Rezoning Transportation Analysis

Petition Number: 2020-018

General Location Identifier: Tax ID 14501314

Date	Description
03-19-20	First Review

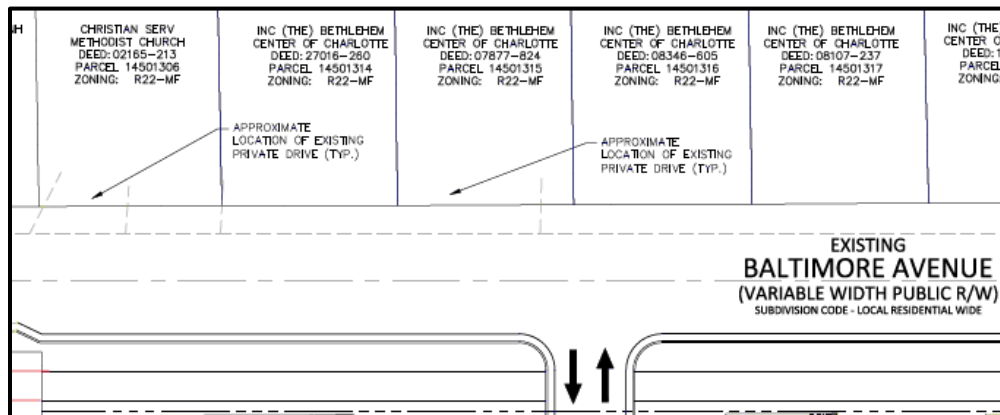
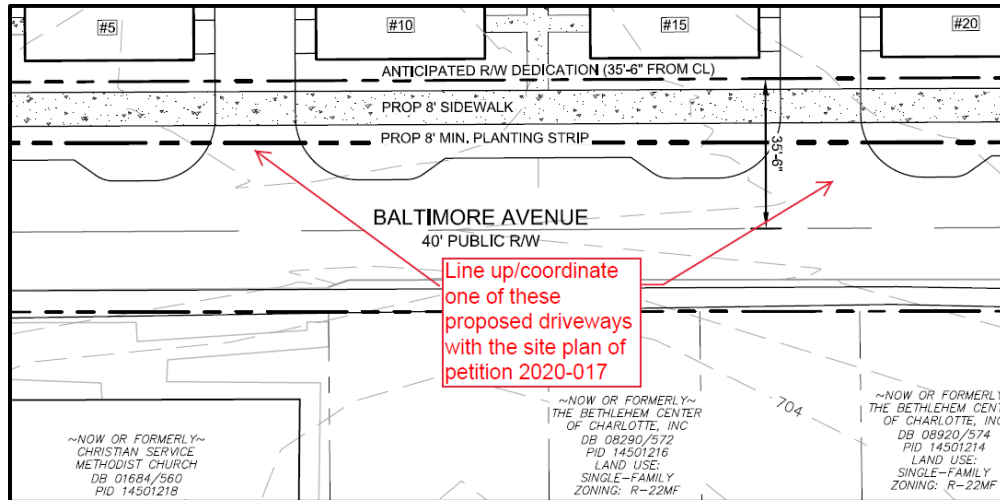
3. We request the petitioner to revise the site plan and conditional note(s) to construct a sidewalk connection to Remount Road with curb and gutter, in reference to the Vision Zero Action Plan and Charlotte WALKS. CDOT has notified Mecklenburg County of the possibility of the petitioner possibly attaining right of way and a construction easement to establish this connection. Please contact Jacqueline McNeil at (Jacqueline.McNeil@mecklenburgcountync.gov) or (+1-980-314-2511) to begin this process. The proposed sidewalk connection will tie-into the proposed improvements requested to rezoning petition 2019-017.

- The petitioner should revise the site plan and conditional note(s) to coordinate with the petitioner of 2020-017 to align one of the two proposed driveways with the proposed access within rezoning petition 2020-017's proposed site plan, or vice versa.
